Access Compliance Report

Public Rights-of-Way (Curb Ramps)

Intersection ID: 18738	Main Street: FERNCLIFF_RD	Cross Street: SHARON_RD	Location: NE
ADA ID: EC1F81C24B07	Ramp Type: PerpDiag	Initial Pass/Fail: Fail	Overall Compliance: No
			Severity Score: 21.25

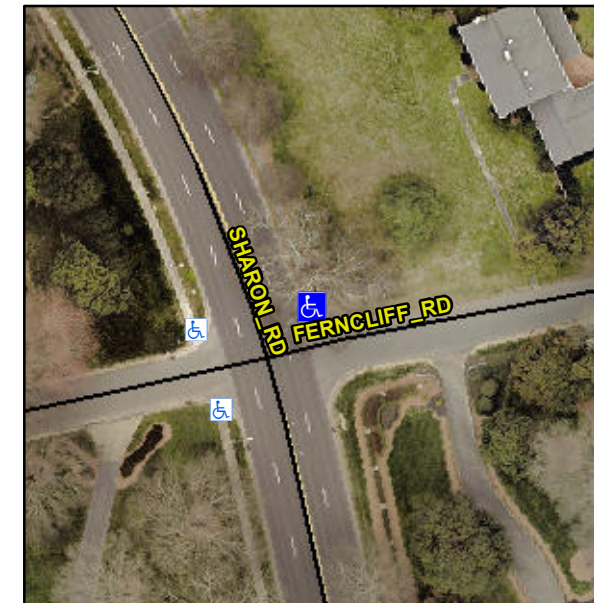
Not Found, R304.5.1, R304.2.2

Compliance	Description	Data	Compliance	Description	Data
N/A	Ramp Length (in)	83.0	No	Ramp Slope (%)	11.2
No	Ramp Width (in)	38.0	Yes	Ramp XSlope (%)	0.2
N/A	Flare Type LT	N/A	N/A	Flare Type RT	N/A
N/A	Flare Slope LT (%)	N/A	N/A	Flare Slope RT (%)	N/A
N/A	Flare Traversable LT?	N/A	N/A	Flare Traversable RT?	N/A
N/A	Landing Length (in)	N/A	N/A	DWS Provided?	N/A
N/A	Landing Width (in)	N/A	N/A	DWS Contrast?	N/A
N/A	Landing Slope (%)	N/A	N/A	DWS Length (in)	N/A
N/A	Landing X Slope (%)	N/A	N/A	DWS Full Width?	N/A
N/A	Landing Curb? (Y/N)	N/A	N/A	DWS Offset (in)	N/A
N/A	Shared Landing?	N/A			
N/A	Gutter Ponding?	N/A	N/A	Gutter Slope (%)	N/A
N/A	Gutter Lip Ht (in)	N/A	N/A	Gutter X Slope (%)	N/A
N/A	Painted X Walk1?	No	N/A	Painted X Walk2?	No
	X Walk 1 Direction	To W		X Walk 2 Direction	To S
N/A	X Walk 1 Width (in)	N/A	N/A	X Walk 2 Width (in)	N/A
	X Walk 1 Slope (%)	4.1		X Walk 2 Slope (%)	1.2
	X Walk 1 X Slope (%)	0.0		X Walk 2 X Slope (%)	7.3

Remove & Replace Curb Ramp With Two New Directional Ramps or Equivalent.
